Addendum No. 2
December 10, 2021

Project: Harrisburg High School - 9th Grade Academy
Sioux Falls, South Dakota
Architecture Incorporated Project #2904

Architect: Architecture Incorporated

SCALE: 1 1/2" = 1'-0"

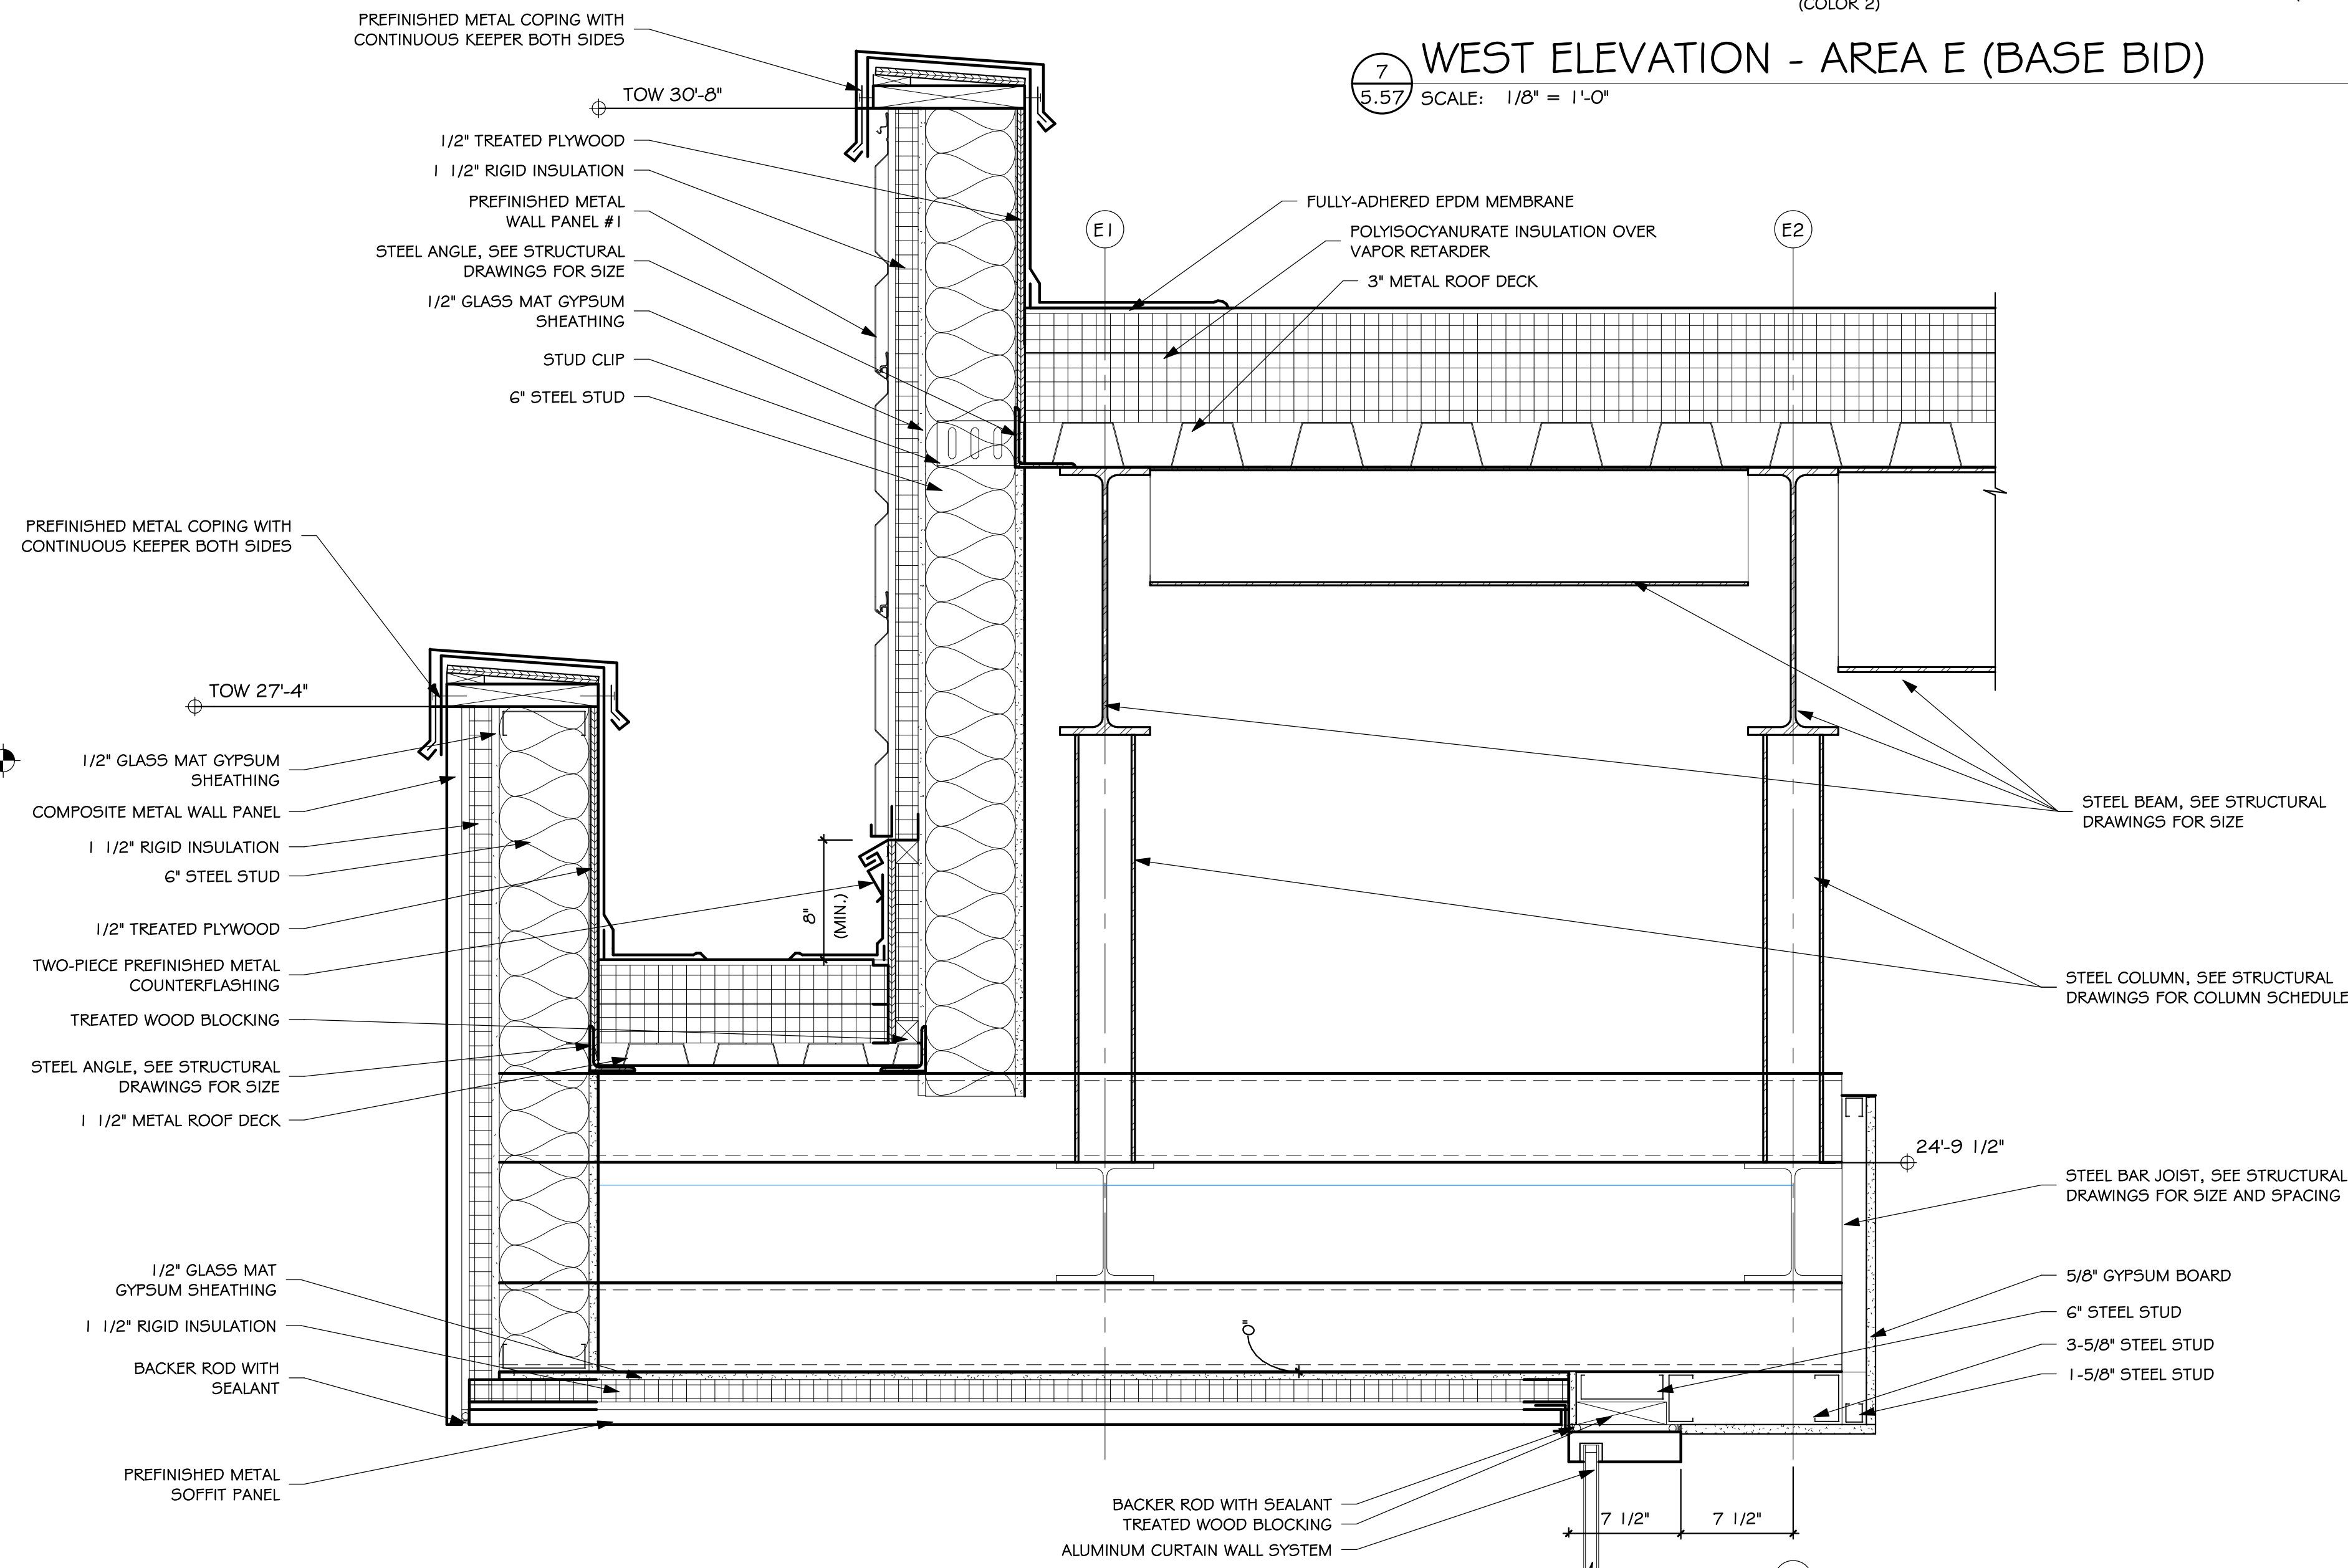
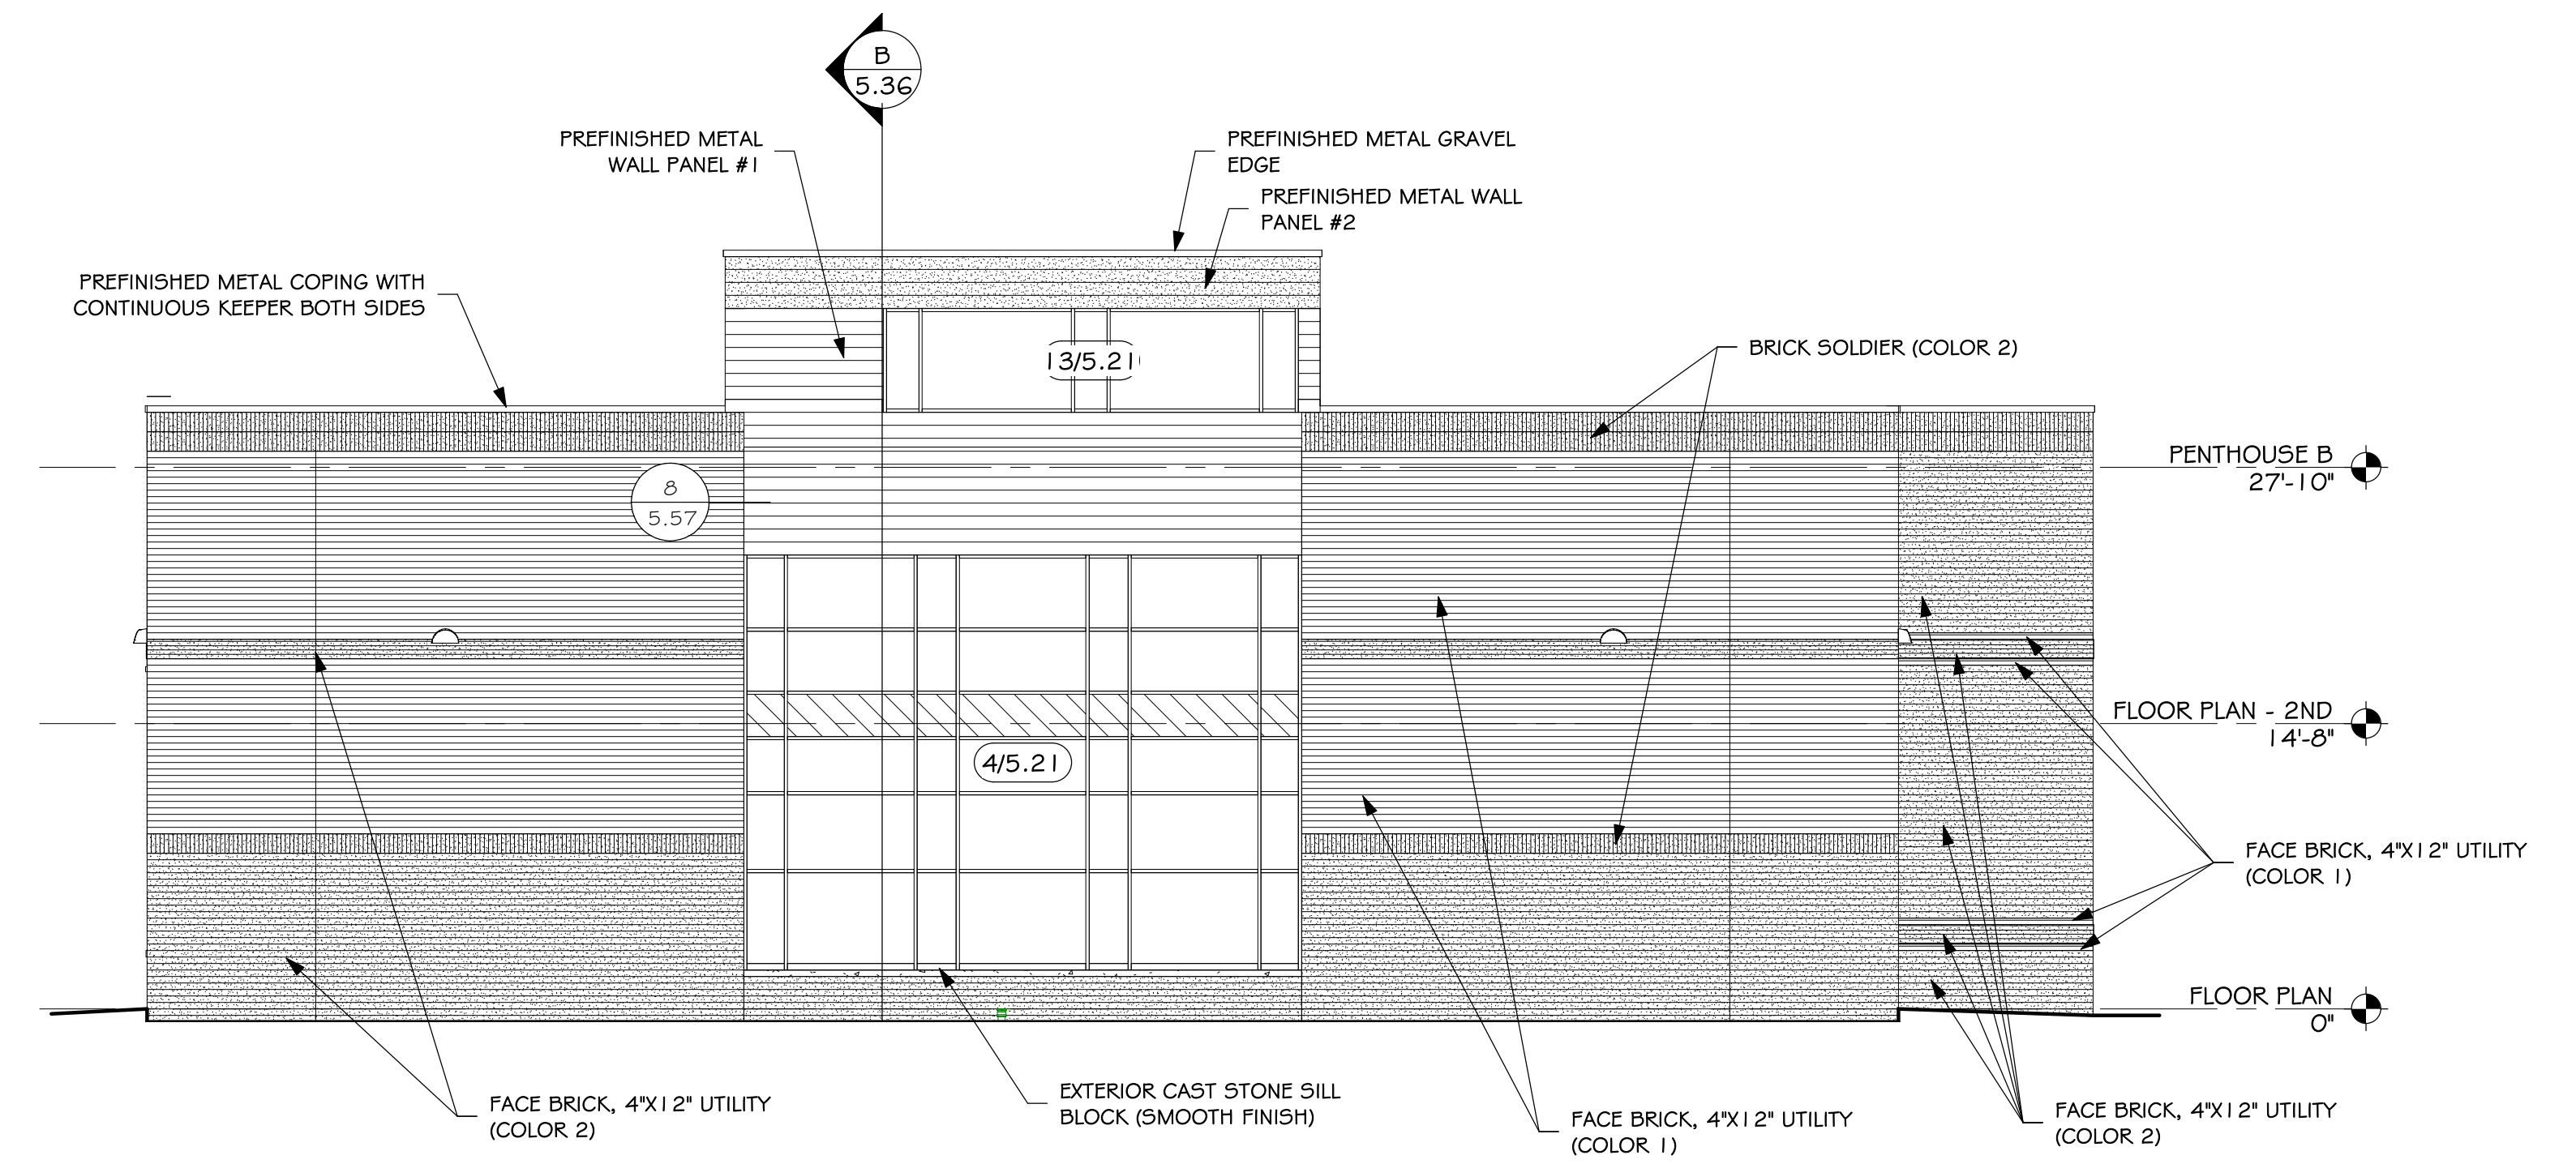
- a) See attached **NEW** architectural drawing Sheet 5.57 with new enlarged details per below:
 - i) Details 1, 2 & 3/5.57 – refer to building section J/5.34, grid EA for location of these details.
 - ii) Details 4, 5/5.57 – refer to building section B/5.36 for location.
 - iii) Reference new exterior building elevation 7 / 5.57 which now shows the west exterior elevation of Area E – per the Base Bid.

6.10-2B

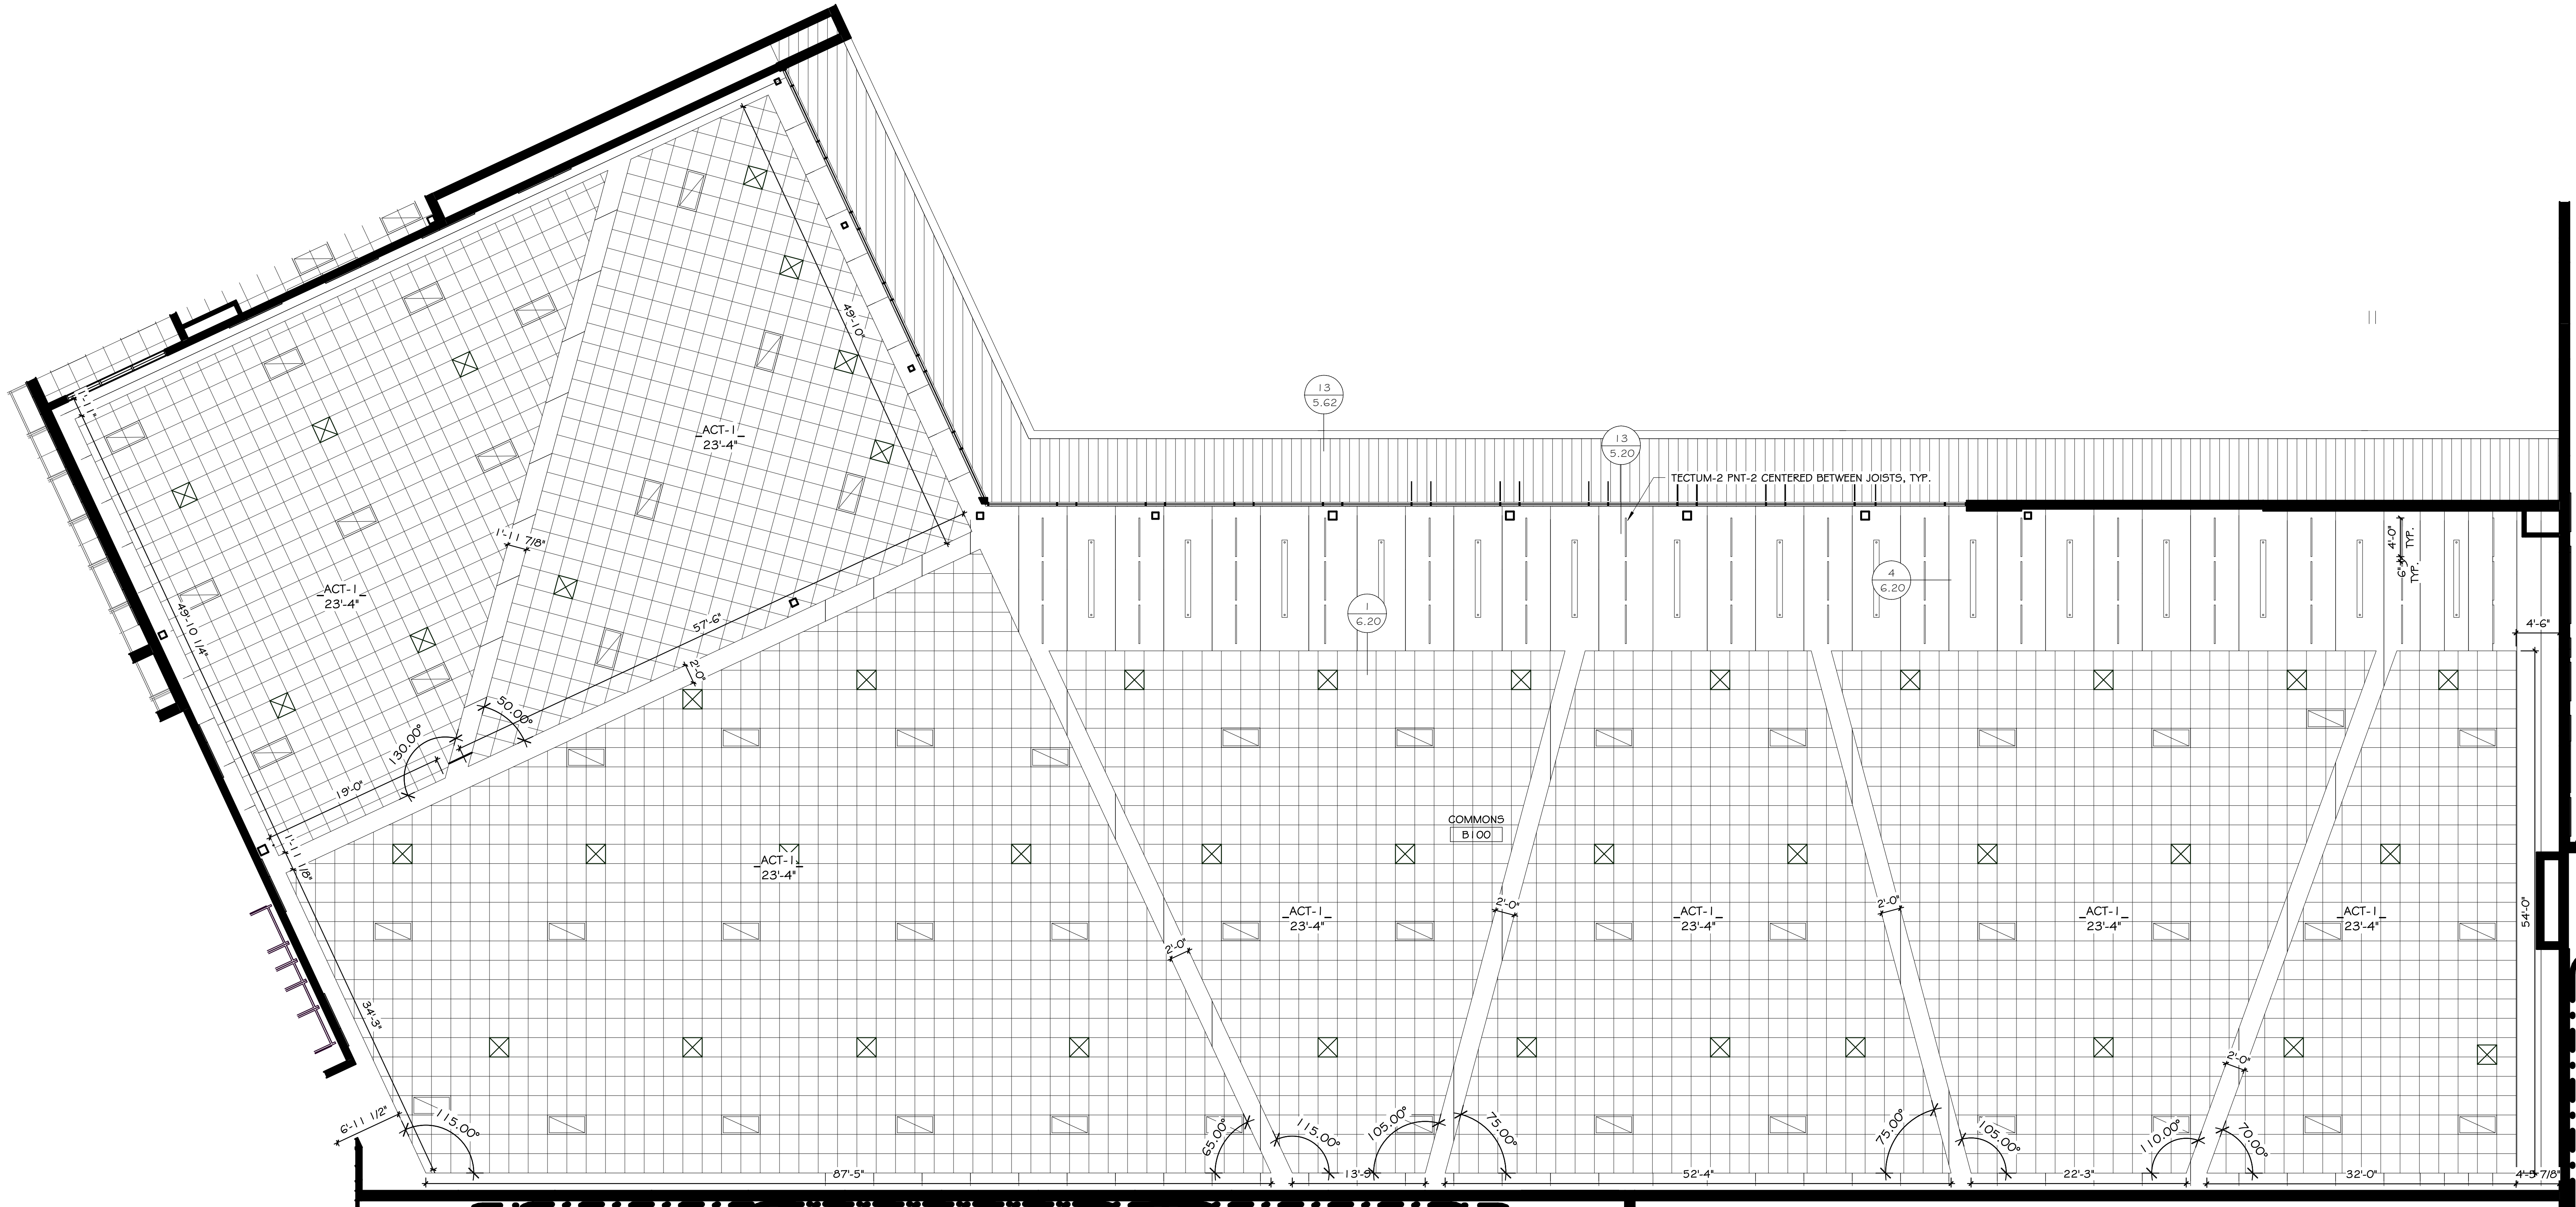
- a) Reference *revised* architectural drawing Sheet 6.10-2B, *revision* dated 12-10-21, attached to the end of this addendum for modifications to the acoustical ceilings in Commons B100, including additional suspended baffles, additional light fixtures and revisions to HVAC ductwork / diffusers.
